Job Reference: 002546-T1
Council Reference: A006836035

RE: RESPONSE TO FURTHER ADVICE DATED 26 MAY 2026 ASSOCIATED WITH DEVELOPMENT APPLICATION ON LAND AT 652 KESSELS RD, UPPER MOUNT GRAVATT, QLD 4017. COUNCIL REFERENCE A006836035.

Amended architectural and landscape plans have been prepared in response to Council's Further Advice dated 26 May 2026, as well as subsequent discussions with, and correspondence received from, Council's Delegate and Assessment Manager.

Figure 1 – Player Street frontage landscaping

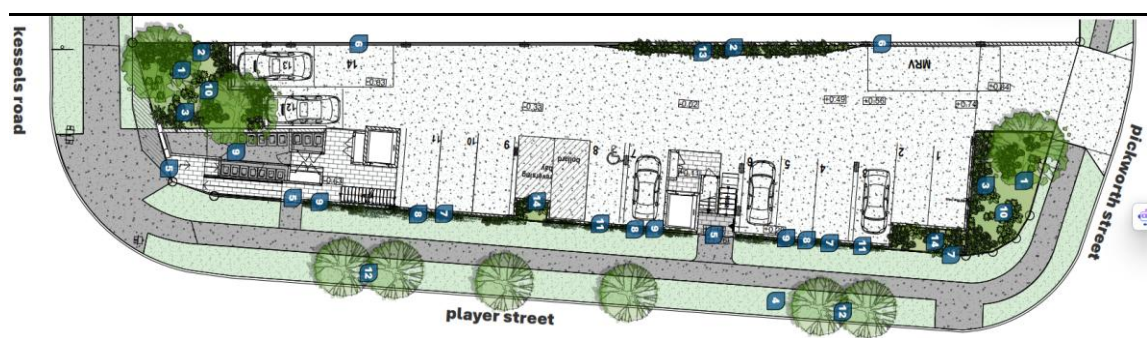
In its most recent correspondence, Council requested further refinements to the landscape plans, particularly regarding the Player Street frontage, the provision of suitable growing media for climbing species, and the technical details of the proposed planter boxes and irrigation system. Specifically, Council requested the following:

- *the landscape outcomes along the Player Street frontage will need to be demonstrated through a detailed Landscape concept plan. The previously submitted LCP was lacking in detail, especially in regard to constrained growing areas along the street frontage.*
- *the LCP should include detailed sections and elevations. Where the climbing species are proposed at the ground level, a detailed section should demonstrate appropriate growing media within the site.*
- *the inclusion of additional planters along the ground level within the car park is positive however these will need to be supported through appropriate soil depth and irrigation*

The proposed streetscape interface along Player Street also remains unchanged and does not provide a sufficient landscaping outcome. In particular, climbing plants are proposed in constrained ground level conditions, with discrepancies between architectural and landscape plans regarding the provision of adequate growing media.

- Introduction of continuous planting strip along the entire Player Street frontage. Retaining wall thickness is reduced along Player Street to provide a planting strip of 200mm deep to cater for trellis and climbing plants. Refer to Figure 1 below;
- Introduction of planter box in front of reversing bay area between car parks 8 & 9. Refer to Figure 1 below;
- Modification of second and third floor planter boxes along Player Street frontage including increased growing media (depth and height) as illustrated on Section BB, Drawing number 03.1 of the revised plans and below in Figure 2;
- Additional deep planting area of 8.3m² adjacent to car parks 1 and 2. Refer to Figure 1 below; and
- Incorporation of perforated screens located on all balcony balustrades to facilitate climbing plant species along the Player Street Façade.

The Player Street frontage incorporates a comprehensive landscape treatment, including climbing species supported by suitable growing areas to achieve an appropriate density and continuity of vegetation along the frontage. The revised retaining wall alignment along Player Street increases the available growing area and enables the vertical planting to be fully contained within the subject site.

A continuous planting zone approximately 200mm in width is proposed along the front boundary. Although the apparent surface width of this planting zone is relatively constrained, it extends continuously along the frontage and will be specifically prepared to accommodate intensive climbing vegetation.

To ensure that plant establishment and ongoing growth are not compromised, the growing profile has been designed as a continuous and unobstructed system. Accordingly, root development will not be confined to the apparent surface width of the planting strip. The prepared growing medium will allow root systems to extend vertically and laterally below the surface, providing sufficient growing capacity to support healthy plant establishment, long-term root development and sustained landscape performance along the Player Street frontage. The revised plans also provide an additional 8.3m² of dedicated landscape area along Player Street.

Figure 2 - Second and third floor planter boxes along Player Street frontage including increased growing media.

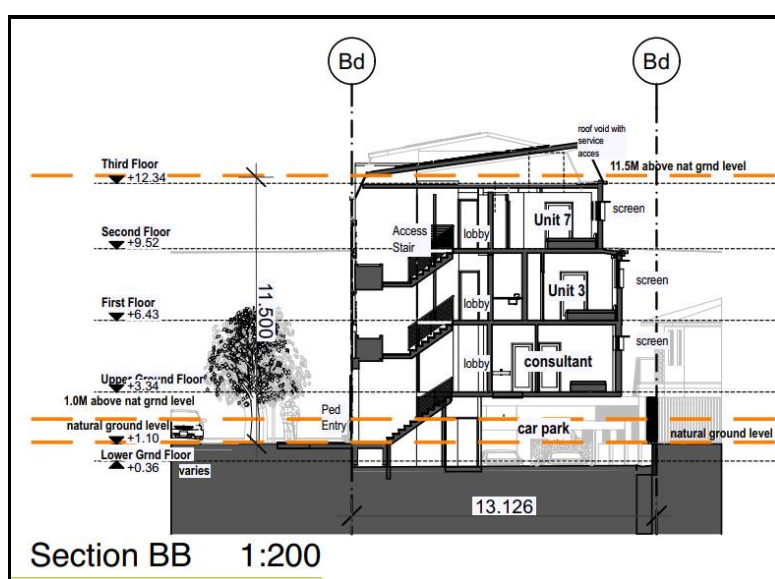
Similarly, the proposed upper-level balcony planters are limited in number and size, restricting opportunities for meaningful greening. The proposal also relies on the adjoining Council verge to provide sufficient growing media. However, this area may be fully paved in the future and cannot be relied upon to achieve on-site landscape outcomes. Accordingly:

- ii. *Provide increased landscaping opportunities within the pedestrian entry ramp and foyer areas.*
 - iii. *iii) Increase planter sizes and quantities on upper-level balconies to achieve a more substantial, multi-layered green façade incorporating climbing and cascading vegetation.*

This vertical greening is structurally supported on the upper levels by modified planter boxes with increased soil depth on the second and third floors, alongside perforated balcony balustrade screens engineered to guide plant growth across the façade.

Figure 3 – Removal of Built to boundary wall resulting in increase setback of 1.5m

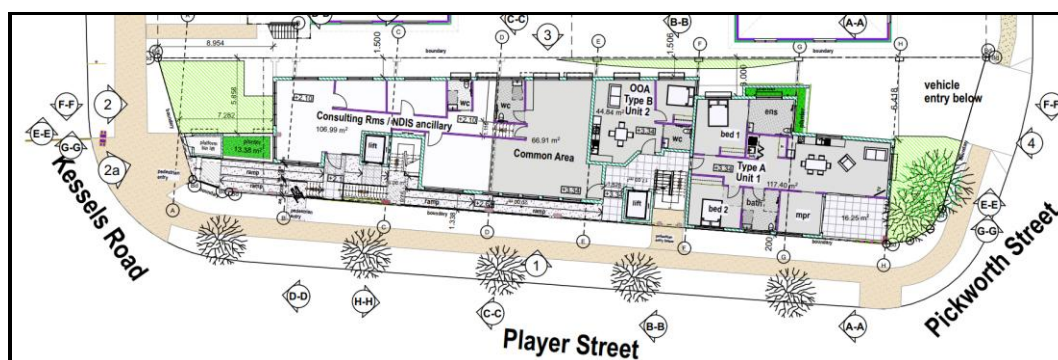
The Information Request response retains the previously submitted built form and does not provide additional separation to adjoining residential properties which are not included within a centre zone. The development does not comply with Acceptable outcomes AO2 and AO9.4 of the Mt Gravatt Corridor neighbourhood plan code. The corresponding Performance outcomes PO2 and PO9 state that buildings are to be well-separated to facilitate reasonable access to sunlight for neighbouring dwellings and their open space, as well as adequate access to breezes and air circulation. Additionally, AO3/PO3 and AO4.2/PO4 of the Multiple dwelling code require that building height transitions be provided. Submit amended plans that demonstrate the following:

- Increased side boundary setbacks to achieve a minimum separation of 1.5m from the adjoining residential property boundary, in lieu of a built-to-boundary wall.*
- Additional variation in building form and articulation along the side boundary façade to reduce visual bulk and improve amenity outcomes for adjoining properties to incorporate the landscape improvements specified in Item 2a) below.*
- Reduced reliance on ‘spider legs’ column to cantilever the proposal as they seem to reach to a double storey height along Pickworth Street and would represent an imposing built form.*
- The annotation of “Mezzanine” for the fourth floor of development should be amended to “Fourth floor”.*

The proposed western side boundary interface retains the previously submitted design and does not incorporate in-ground landscaping. While containerised planters are proposed, these are limited in size and extent, and do not adequately offset the built form or improve the interface with adjoining properties as currently proposed.

- i. *In the absence of an in-ground landscape buffer, increase the upper-level setback and incorporate continuous deep planters along the length of the built form at Level 2. Planters are to be located just above the fence line and provide a minimum soil depth of 0.8m, capable of supporting columnar screening shrubs to a minimum height of 3m.*

- Removal of Built to boundary wall and resultant increase of side setback to 1.5 meters for the first 33 meters of the building. The current proposed setbacks range from 1.5 meters to 3 meters and up to 6.4 meters along the western boundary. These modifications to the western boundary interface with respect to setbacks deliver increased amenity and privacy outcomes for the adjoining dwelling. Refer to Figure 3 below.
- Incorporation of additional deep planting area within car park along the western boundary. Deep planting area will assist in achieving the desired visual amenity outcome for adjoining property, will soften the built form and reduce the perceived bulk of the proposed dwelling. Refer to Figure 3 below.
- Incorporation of L-shaped planter box on the first floor as well as trellis system to support climbing plant species. Refer to Figure 3 below.

In response to Council’s request, and following discussions with Council’s Assessment Manager and Delegate, the previously proposed built-to-boundary wall along the western boundary has been removed. As a consequence of this amendment, the development now provides increased side boundary setbacks, resulting in greater separation from the adjoining property and an improved interface along the western boundary. We highlight, the revised side boundary setback commences at 1.5 meters and progressively increases to 3 meters and upto 6.4 meters along this boundary.

The amended plans demonstrate improvements to the western side boundary interface, including the introduction of in-ground landscaping. The additional landscape buffer will assist in softening the presentation of the built form and improving the visual relationship between the development and the adjoining residential properties.

Planter box (L-shaped) and Trellis climbing plants are provided along the western boundary. Given its L-shaped design, this planter enhances the existing streetscape and softens the built form.
